Appln no. 10/668,410

Amendment dated April 12, 2005

Response to Office Action of Oct. 20, 2004

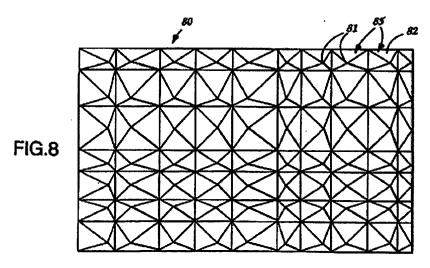
Reproduced below is FIG. 8 from Hoopman. FIG. 8 illustrates an abrasive article 85 with abrasive composites 80 having faces 82 and apex 81. Applicant agrees that some of the composites 80 have an apex 81 that is offset from the center of the composite base. However, as can be seen in FIG. 8, the offset of the distal regions is random, and the sum of the vectors of the offset does appear to approach zero.

The pending claimed invention differs from the teachings of Hoopman, including the illustration of FIG. 8, in that the pending claims recite that "the offset vectors for the plurality of protruding units do not exhibit a sum that approaches a limit of zero" (see claim 1, lines 10-11; claim 9, lines 10-11). There is no discussion in Hoopman of having the sum of the offset vectors not approach a limit of zero.
